MEMORANDUM

SUBJECT: Public hearing and consideration of an application for a

Landmark Alteration Certificate to build a 451 sq. ft.

detached, one-car garage with second-story studio at 820 Spruce St. in the Mapleton Hill Historic District, per section 9-11-18 of the Boulder Revised Code 1981 (HIS2015-00151).

Figure 8. Proposed garage outlined in yellow.

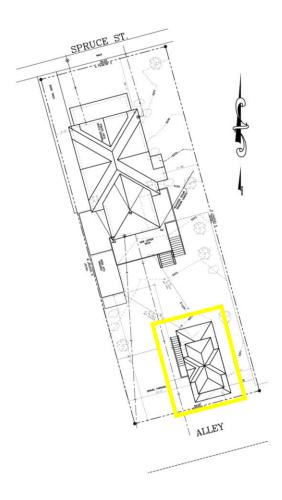
- 2. Prior to submitting a building permit application and final issuance of the Landmark Alteration Certificate, the applicant shall submit a revised design that simplifies the mass and design of the proposed garage including the roof form to ensure that it is more subordinate to and compatible with the historic house and character of the alleyscape.

Staff considers that the design of the garage should be simplified to provide for a one, or one and one-half story garage with massing and roof form complementary to the contributing house on the property. The two-story form with complex, low-pitch roof forms is inconsistent with the character of the property and the district as a whole. Staff considers that the Landmarks design review committee (Ldrc) can review and approve a design that is simplified and reduced in scale as described.
